SUBJECT: COMANCHE PEAK NUCLEAR POWER PLANT, UNITS 3 AND 4  
DOCKET NUMBERS 52-034 AND 52-035  
SUPPLEMENTAL RESPONSE TO REQUEST FOR ADDITIONAL INFORMATION  
NO. 4206 (SECTION 12.3-12.4)

**SUPPLEMENTAL RESPONSE TO REQUEST FOR ADDITIONAL INFORMATION**

**RAI NO.: 4206 (CP RAI #135)**

**QUESTION NO.: 12.03-12.04-11**

CP COL 12.3(10) Figure 12.3-201 Yard Piping Routing and Building Penetration Schematic for CPNPP Unit 3 (Not to scale)

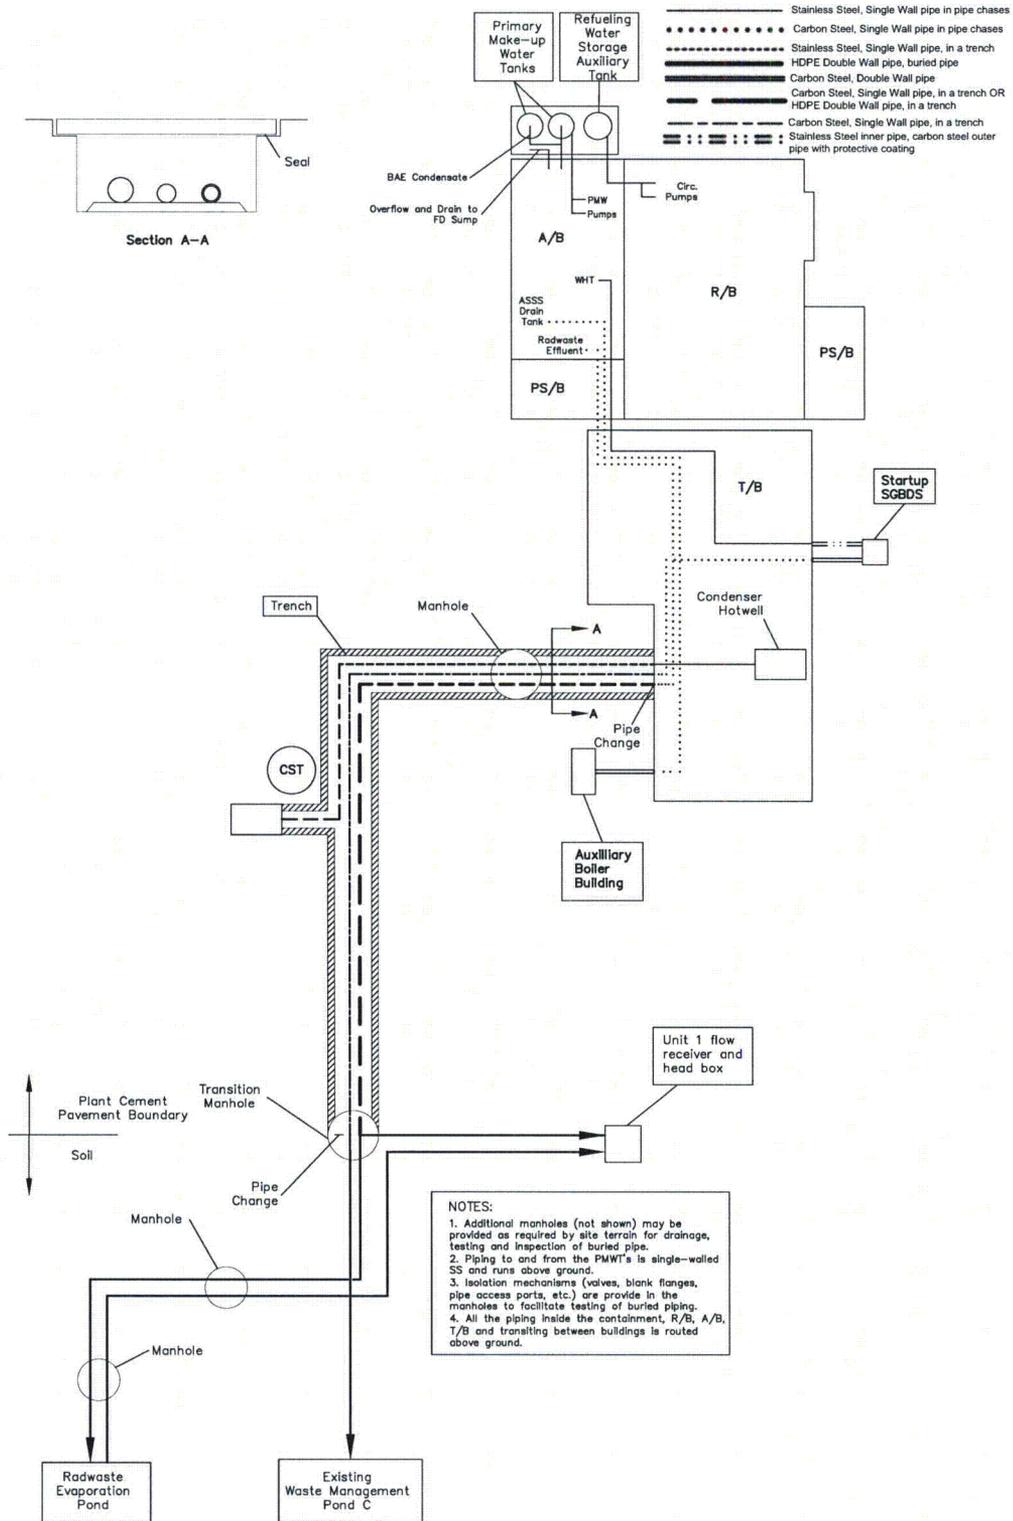
**Does Luminant intend to provide similar information for the dike surrounding the CST?**

- Subsection 9.2.6.2 – revised to state that the CST for Unit 3 is located on west side of Unit 3 as depicted on Figure 12.3-201, while the Unit 4 CST is located on the east side of Unit 4, as depicted on Figure 12.3-202.
- Subsection 10.4.8.2.1 – revised to refer to Figures 12.3-201 and 12.3-202.
- Subsection 11.2.3.4 – clarified the description of the piping run for Unit 3 and Unit 4.
- COL Action Item 12.3(10) – added Figure 12.3-202.
- Table 12.3-201, Sheets 1 and 2 – clarified the description of the piping runs for Unit 3 and Unit 4.
- Table 12.3-201, Sheet 4 – clarified the description of the piping run from the turbine building to the yard.
- Figure 12.3-201 – revised figure to show that it is now only applicable to Unit 3.
- Figure 12.3-202 – added new figure for Unit 4 yard piping routing and building penetration schematic.

The condensate storage and transfer system consists of one CST for each unit. The CST for CPNPP Unit 3 is located on the west side of CPNPP Unit 3. CPNPP Unit 4 CST is located on the east side of CPNPP Unit 4. Figures 12.3-201 and 12.3-202 depict this layout. Each CST has two 100% capacity condensate transfer pumps, and associated valves, piping, and instrumentation.

**CP COL 12.3(10) Figure 12.3-202 Yard Piping Routing and Building Penetration Schematic for CPNPP Unit 4 (Not to scale)**

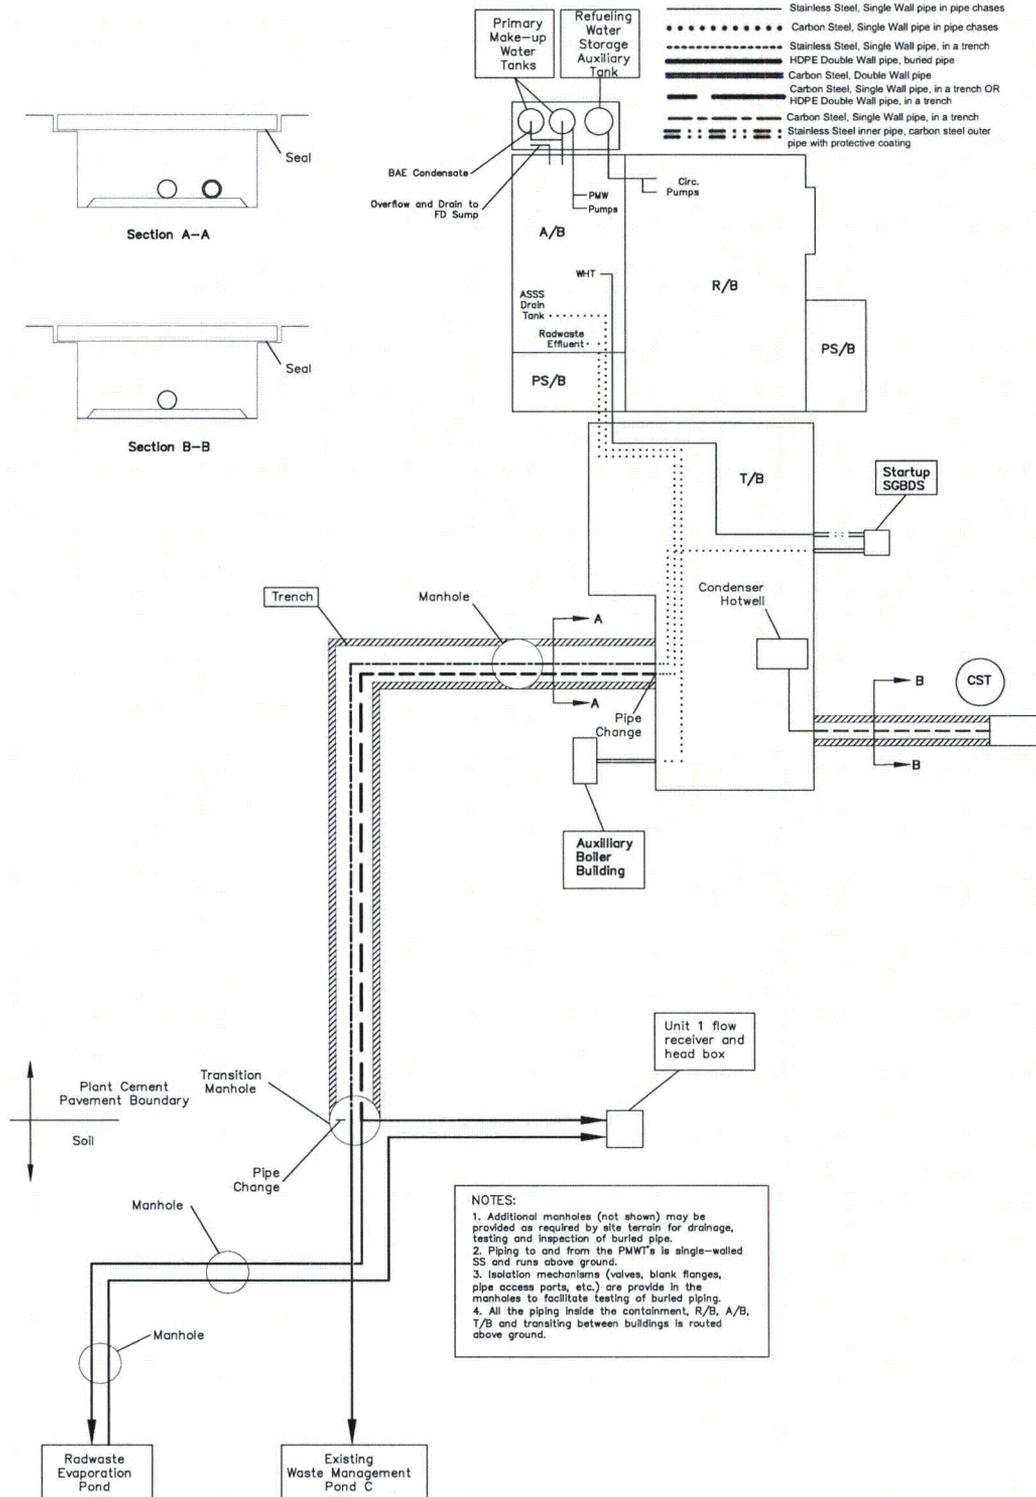
During the revision of the grading and drainage plan, it was discovered that the Unit 4 CST and transfer pumps could not be located on the west side of Unit 4 in the same configuration as Unit 3 due to plant layout restrictions. The previous response to this question (ML11213A098) indicated that the transfer piping from the Unit 4 CST is identical to the transfer piping from the Unit 3 CST. Luminant is providing this supplemental response to revise the Unit 4 CST and transfer piping as follows:

This discharge line consists of the following piping segments for CPNPP Units 3 and 4 as depicted in Figures 12.3-201 and 12.3-202:
